Re: Docket 423  
North Atlantic Towers, LLC and New Cingular Wireless PCS, LLC ("AT&T")  
Certificate of Environmental Compatibility and Public Need  
Route 198, Woodstock, Connecticut  
D&M Revision and  
Request for an Extension of Time for the Facility to Become Operational

D&M Revision

# Structural Analysis 110-ft Monopole

**SITE NAME: WOODSTOCK RT 198**  
**SITE NUMBER: CT2067**  
**ADDRESS: ROUTE 198**  
**WOODSTOCK, CT 06282**

**RF EQUIPMENT PLAN**  
SCALE: 1"=3' (11x17)  
1"=6' (22x34)

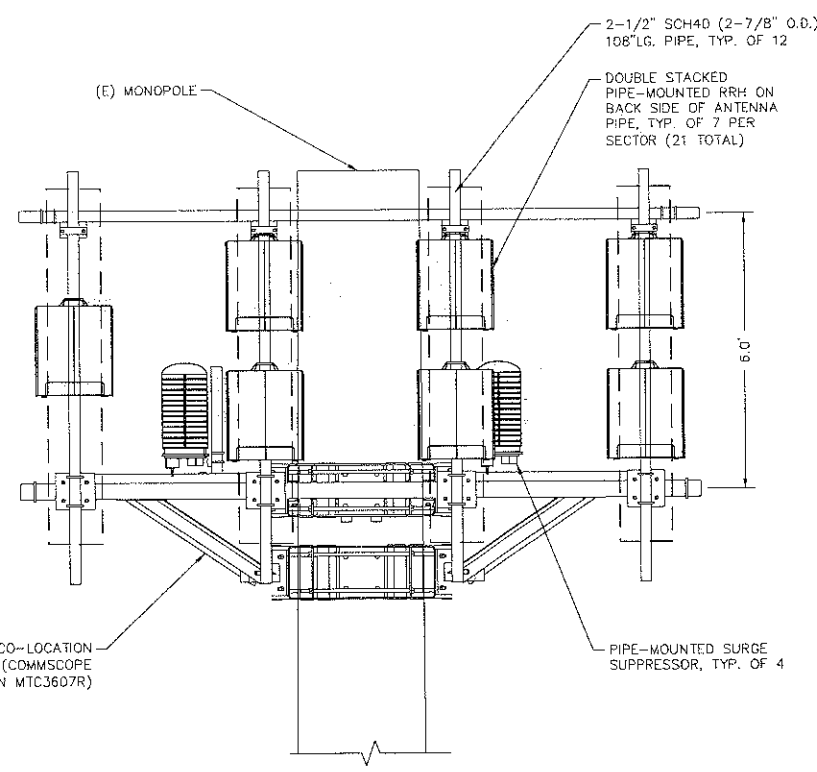
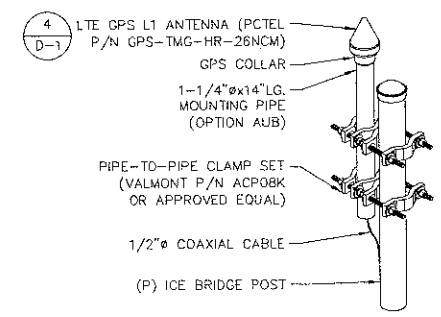
The revised D&M Plan drawings incorporate revised specifications for AT&T's LTE facility. The revisions include the addition of one panel antenna per sector, for a total of twelve antennas. The revisions also include the addition of Remote Radiohead Units ("RRUs") for a total of twenty-one (21). As shown in the enclosed drawings, the RRUs will be installed behind AT&T's twelve panel antennas on the antenna platform mount at a centerline height of approximately 106' above grade level on the existing 110' tall tower. The enclosed drawings also included updated specifications for AT&T's panel antennas.
